# Access Compliance Report

## Public Rights-of-Way

### (Island Curb Cuts)

Intersection ID: 52583	Main Street: NEW_RENAISSANCE_WY	Cross Street: BURNETTE_AV	Location:	N/A
ADA ID: 390667EAAA39	Curb Cut Type: MedianRefuge2	Initial Pass/Fail: Fail	Overall Compliance: No	Severity Score: 25
Codes/Mitigation Info/Possible Solution		Field Measurements/Component Compliance

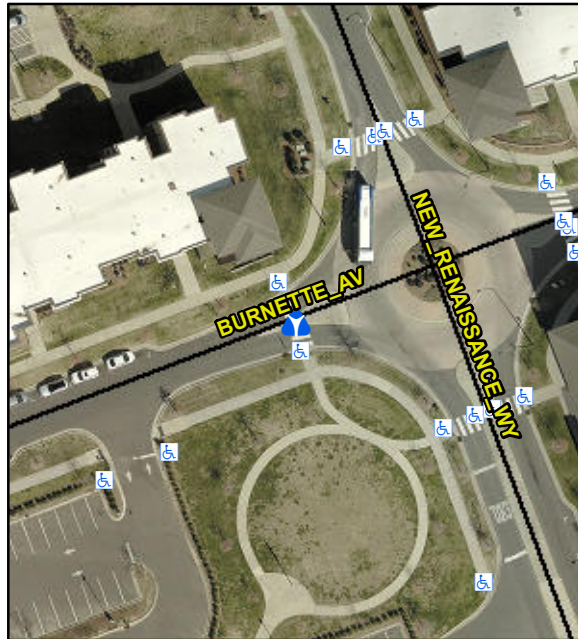
Compliance	Description	Data	Compliance	Description	Data
No	Refuge 1 Length (In)	31.5	N/A	Gutter 1 Ponding?	N/A
Yes	Refuge 1 Width (In)	74.0	N/A	Gutter 1 Lip Ht (In)	N/A
No	Refuge 1 Slope (%)	6.8	N/A	Gutter 1 Slope (%)	N/A
No	Refuge 1 X Slope (%)	6.2	N/A	Gutter 1 X Slope (%)	N/A
N/A	Painted X Walk1?	Yes	N/A	DWS 1 Provided?	N/A
N/A	X Walk 1 Direction	To SE	N/A	DWS 1 Contrast?	N/A
N/A	X Walk 1 Width (In)	120.0	N/A	DWS 1 Length (In)	N/A
N/A	Road 1 Slope (%)	5.2	N/A	DWS 1 Full Width?	N/A
N/A	Road 1 X Slope (%)	4.4	N/A	DWS 1 Offset (In)	N/A
No	Refuge 2 Length (In)	31.5	N/A	Gutter 2 Ponding?	N/A
Yes	Refuge 2 Width (In)	74.0	N/A	Gutter 2 Lip Ht (In)	N/A
Yes	Refuge 2 Slope (%)	2.9	N/A	Gutter 2 Slope (%)	N/A
No	Refuge 2 X Slope (%)	6.4	N/A	Gutter 2 X Slope (%)	N/A
N/A	Painted X Walk2?	Yes	N/A	DWS 2 Provided?	N/A
N/A	X Walk 2 Direction	To NW	N/A	DWS 2 Contrast?	N/A
N/A	X Walk 2 Width (In)	120.0	N/A	DWS 2 Length (In)	N/A

**Remove & Replace Entire Refuge.**
